UNITED STATES
NUCLEAR REGULATORY COMMISSION
REGION IV
URANIUM RECOVERY FIELD OFFICE
BOX 26326
DENVER, COLORADO 80226

MEMORANDUM FOR: Docket File 40-8907
FROM: Joel P. Grimm, Project Manager
SUBJECT: REVIEW OF GEOLOGIC AND GEOMORPHIC ASPECTS OF THE
UNC-CHURCH ROCK RECLAMATION PLAN

Figure 2: Detailed topographic map of the approximate tailings disposal area and its relationship to Pipeline Arroyo.

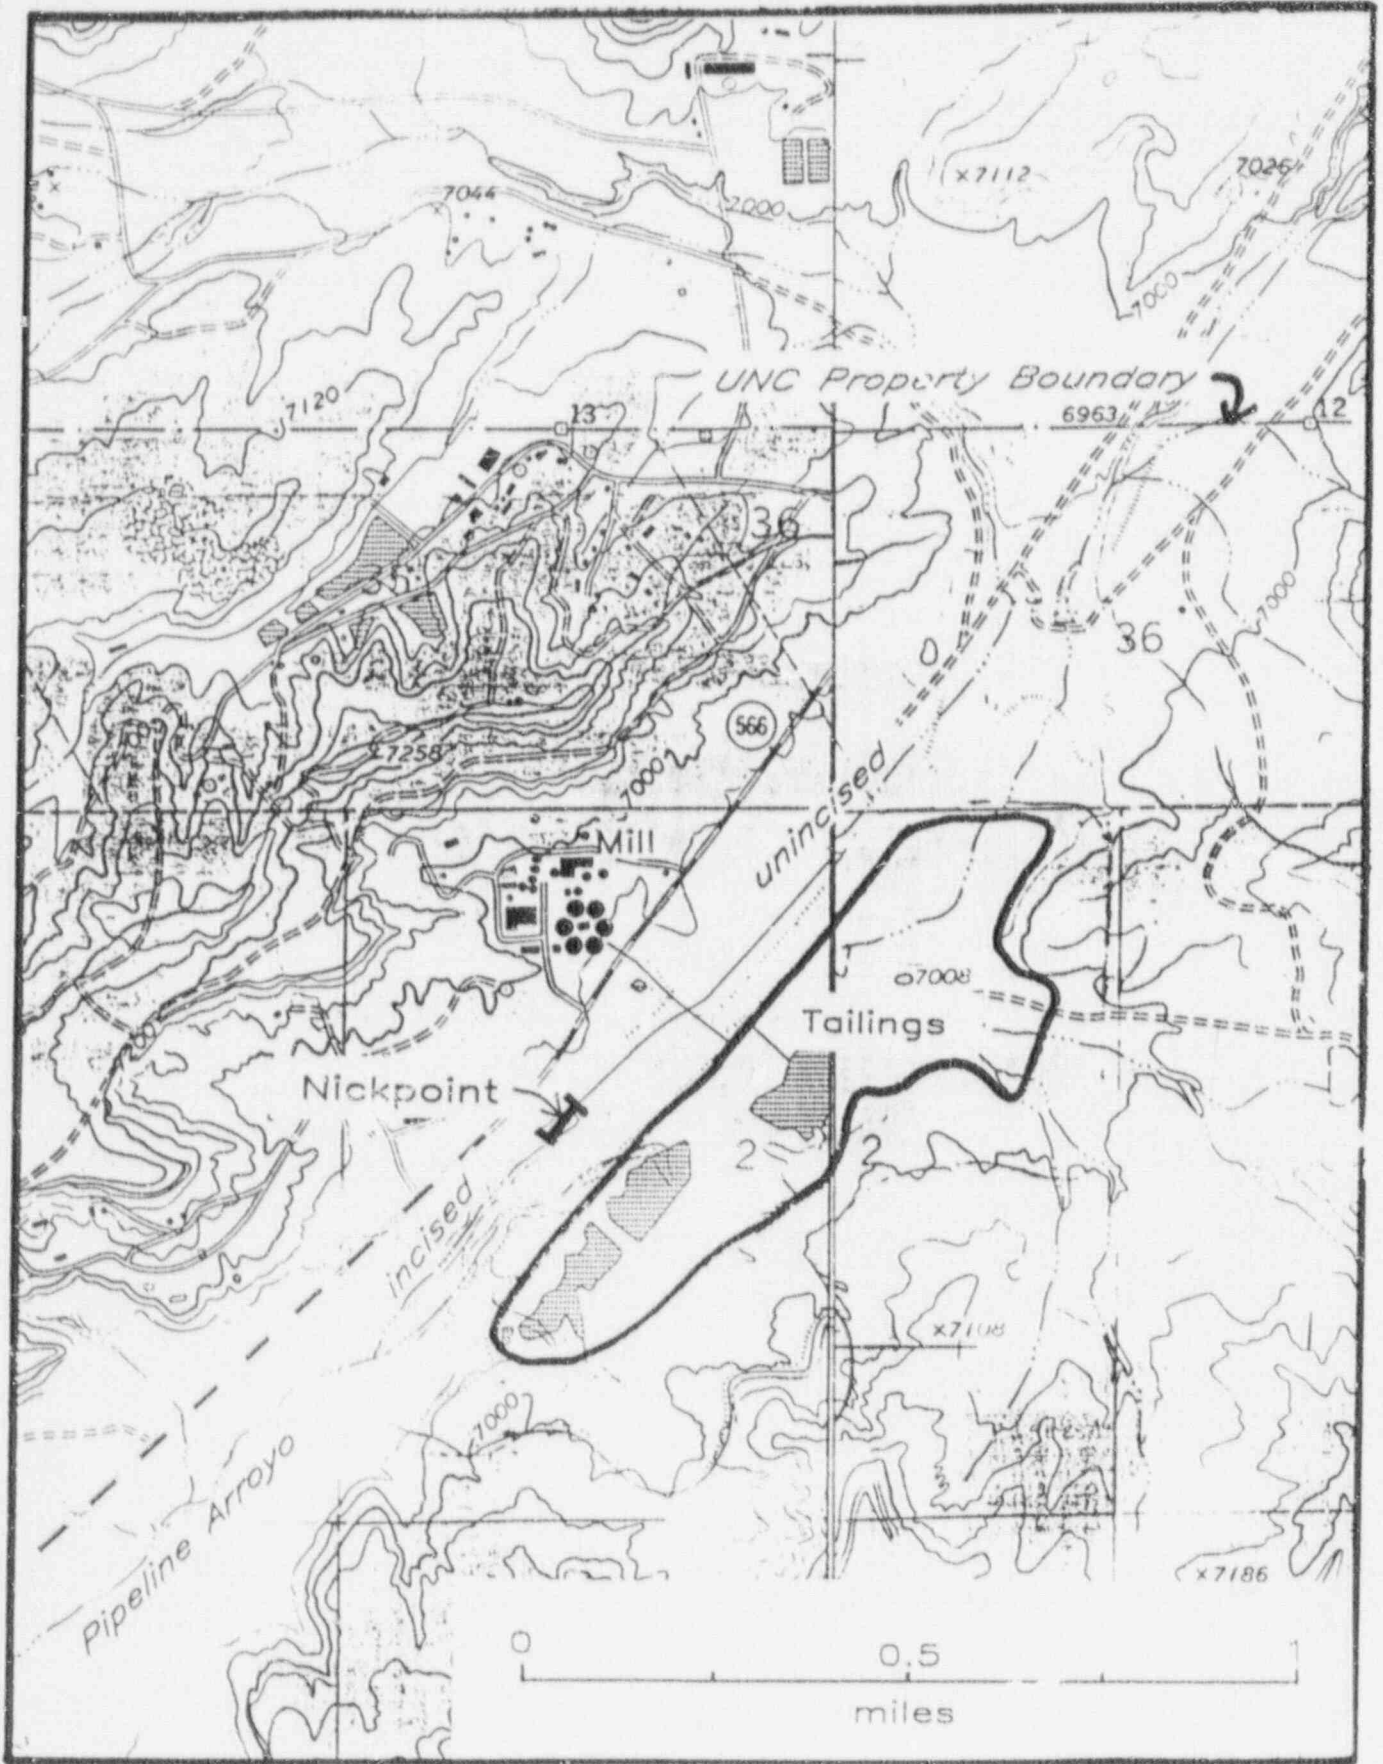
Pipeline Arroyo is a channel incised in excess of 10 meters adjacent to the pile (fig. 2). The arroyo's vertical banks are subject to mass wasting and erosion, as revealed by aerial photographs and field observations. The channel gradient in the deeply incised area is approximately 0.018. The arroyo has headcut upstream from the Rio fuerco. Approximately one-third of the way northward along the tailings pile, Pipeline Arroyo encounters resistant sandstone bedrock in its channel. The channel rises steeply in a short distance, resulting in a nickpoint that comes to nearly the same elevation as the valley floor. The arroyo no longer occurs upstream, and the channel is unincised on a wide valley floor (fig. 2). The unincised area is a sediment storage area, maintaining a very low channel gradient of only 0.002 (Table 1).

The applicant's goal is stabilization of the pile for the required 1000 years, using a PMF as the design basis. The applicant originally proposed to excavate through the nickpoint, creating one continuous, straight, and deep channel from the northern property boundary (fig. 2) to beyond the southern end of the tailings pile. The design included lowering the channel in excess of 8 meters at the nickpoint, creating 2:1 sideslopes in the bedrock reach, knocking down the vertical gully walls in alluvial reaches to 3:1 sideslopes, and steepening the channel gradient upstream to about 0.008, and downstream up to 0.025. The goal of this design was to contain the PMF within the excavated channel, preventing high-velocity flow along the tailings embankment. The entire reach of Pipeline Arroyo along the tailings and up-valley would be channelized, and would mostly occur in alluvium. Most importantly, the tailings embankment is adjacent to the channel for a distance exceeding 400 meters, with no intervening buffer area.

Considering the site characteristics and geomorphic concepts discussed above, it is concluded that geomorphic conditions downstream of the nickpoint are unstable, and the southern one-third of the tailings pile is in jeopardy of becoming involved in arroyo widening. In addition, removal of the nickpoint and channelization of the northern area will result in destabilization of that area, including the area where no buffer area occurs between the embankment and channel. Specifically, the unincised area's valley gradient is probably as steep as is stable. If a gradient steeper than 0.002 were stable, excess sediment would have been deposited upstream to raise valley slope. Thus, the northern part of the site will become susceptible to basin rejuvenation if altered. Without considerable engineered enhancements to this design, it is concluded that the proposal is not likely to provide stabilization of the

- 1) Changing the proposal to excavate the northern channel. Instead, the existing channel will be altered only to provide a low-flow channel 30 feet wide from the northern property line to the nickpoint. Erosion of the tailings embankment during extreme events will be minimized by construction of an erosion resistant berm along the embankment interceptor ditch at the calculated level of the PMF.

- 2) Abandoning the proposal to remove the nickpoint by excavation. Instead, the nickpoint will be reinforced with a buried riprap jetty from the exposed bedrock, through the subsurface, to the tailings embankment. This proposal will provide stable base level for the drainage basin north of the nickpoint.

- 3) Leaving the arroyo south of the nickpoint relatively unaltered. The area known as the sacrificial slope will be regraded to promote sheet flow of direct runoff. In addition, the base of the tailings embankment will be ringed by an interceptor ditch, and runoff from the embankment will be diverted to a controlled structure.

Figure 3: Model of arroyo development in different sediment, based on field studies and laboratory simulations. Pipeline Arroyo conditions are similar to those in the central column (from Meyer, 1989; Figure 37).

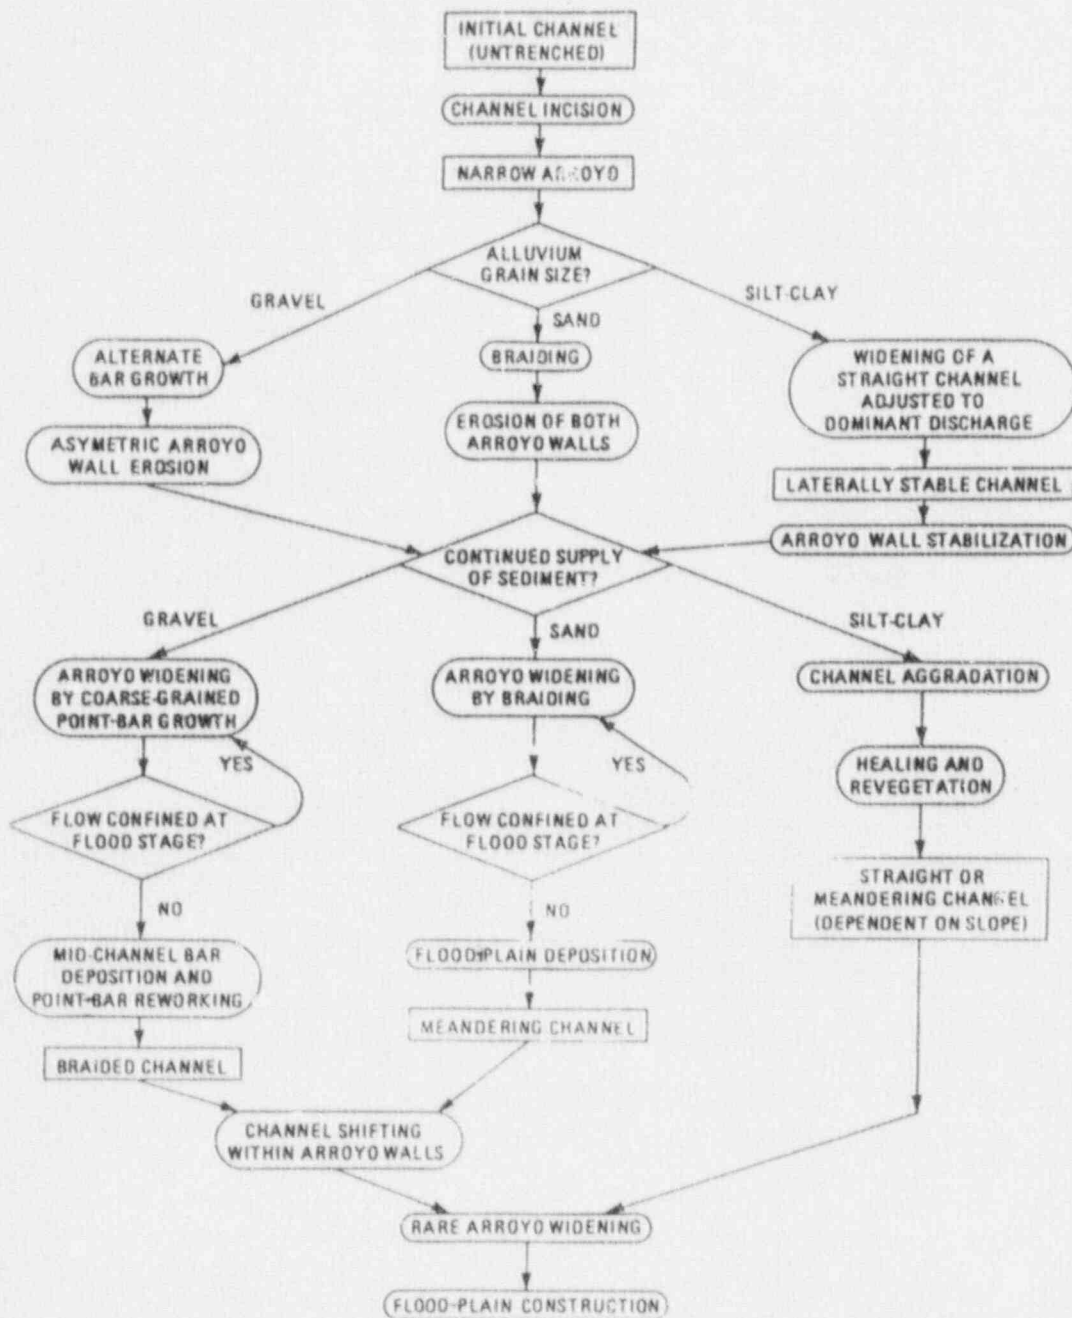
braided bars and the active channel occupies the entire arroyo floor (Meyer, 1989). Both arroyo walls are nearly vertical, and the arroyo experiences large amounts of widening by bank failure and erosion (fig. 3). These findings resemble existing conditions in Pipeline Arroyo. Unstable conditions continue for extended periods of time, and stability is not achieved until large volumes of sediment are removed, and sediment production upstream abates (Meyer, 1989).
